U.S. Army Corps of Engineers (USACE) TRANSMITTAL OF SHOP DRAWINGS, EQUIPMENT DATA, MATERIAL SAMPLES, OR MANUFACTURER'S CERTIFICATES OF COMPLIANCE For use of this form, see ER 415-1-0; the proponent agency is CECW-CE	DATE 2/14/2023	TRANSMITTAL NO. 23 30 00-3.1
---	-------------------	---------------------------------

SPECIFICATION SEC. NO. (Covers only one section with each transmittal) 23 30 00-HVAC Air Distribution	PROJECT TITLE AND LOCATION 01 FY22 81st NC026 HEP Reset; W'ville, NC, Winterville, NC	THIS TRANSMITTAL IS FOR: (Check one) <input type="checkbox"/> FIO <input checked="" type="checkbox"/> GA <input type="checkbox"/> DA <input type="checkbox"/> CR <input type="checkbox"/> DA/CR <input type="checkbox"/> DA/GA
--	--	---

PROJECT: NC026 Army Reserve Center Reset

Fan Coil Units

Coil/Unit Handing Guide

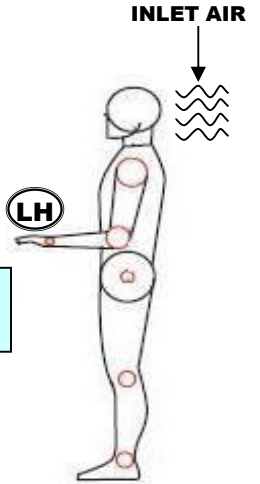
1. All submitted fan coil units are the correct hand (Left Hand).
Engineer has no exception to the handing. Please note, handing is determined by looking in the direction of supply airflow as depicted in the included the Coil/Unit Handing Guide.
2. Provide 2” racks with 2” MERV 13 Filters as scheduled.
The units come standard with a filter rack for 2” MERV 8 filters. A separate set of 2” MERV 13 filters will be provided for all units.
3. In all cases, the submitted fan coil units exceed the Basis of Design dimensions scheduled on sheet M-604. Verify with the installing Contractor that the larger units will fit, otherwise resubmit units within the scheduled dimensions.
The submitted fan coil unit dimensions were checked against drawings MH101 and MH102 and look possible for installation.
